The Boulevard, Punchbowl, Affordable Housing
(SSD-83256463)

**150 The Boulevard and 34 Dudley Street,
Punchbowl | Affordable Housing**

Stormwater: Item 1.1

Figure 1: Excerpt from MM drawing number C-0051, Rev. 02

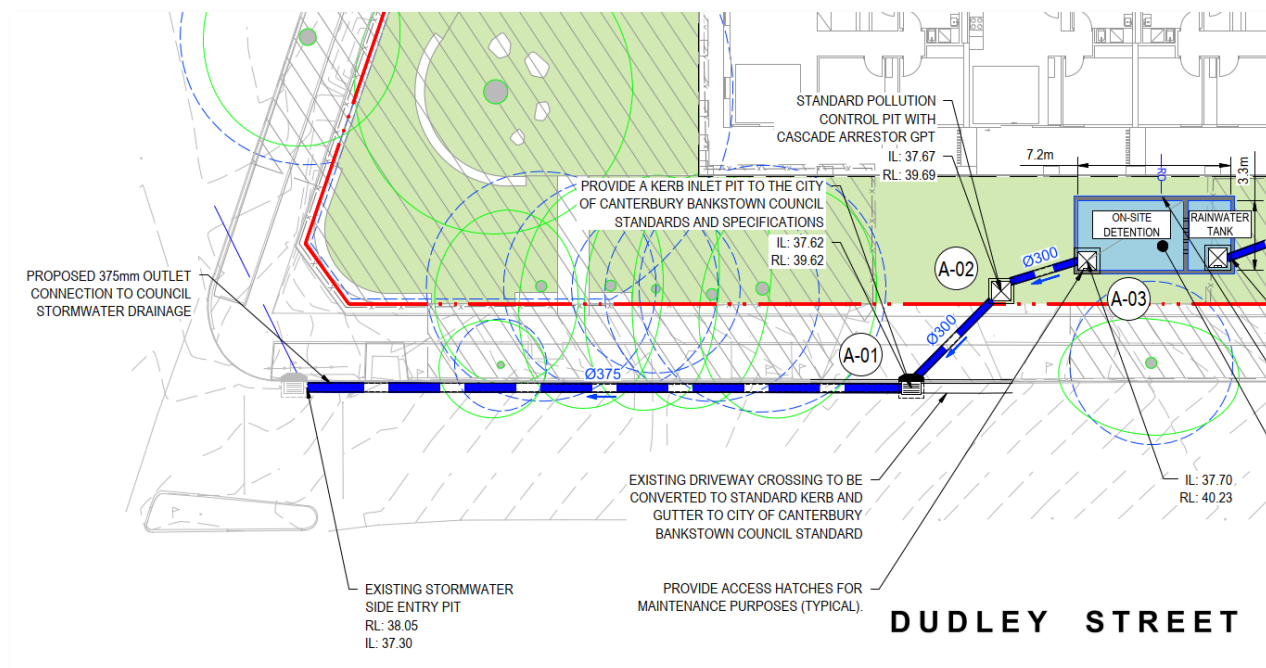
CBC Comment: *"The proposed design is intrusive requiring the installation of a new 375 Ø new concrete pipe (approximately 25m long along the kerb line within Dudley Street). The site enjoys a generous natural slope which provides an ideal platform for a less intrusive stormwater design following the natural slop, where stormwater can easily be discharged onto the kerb within Boulevard without the need for a new street stormwater system along Dudley Street, this kind of design is reserved for difficult, restricted and flat site with hardly any slope, which is not the case for the subject site."*

CBC Comment: “Pit Connection Details - Confirm the size and depth of existing pit being connected into, and invert levels of existing pipe immediately located downstream. Ensure that the proposed design allows stormwater to drain by gravity.”

MM Response: The additional DN375mm pipe in the public domain was proposed to avoid placing the OSD further downstream, where there are trees to retain. This decision to run the proposed pipe in the public domain was coordinated with the project arborist, Arterra, to prevent encroaching on the existing retained trees' TPZ. Please refer to the snapshot in Figure 1 below.

MM Response: The required information is detailed in the civil plan prepared by Mott MacDonald, drawing number C-0051, Rev. 02. Please refer to Figure 1 above.
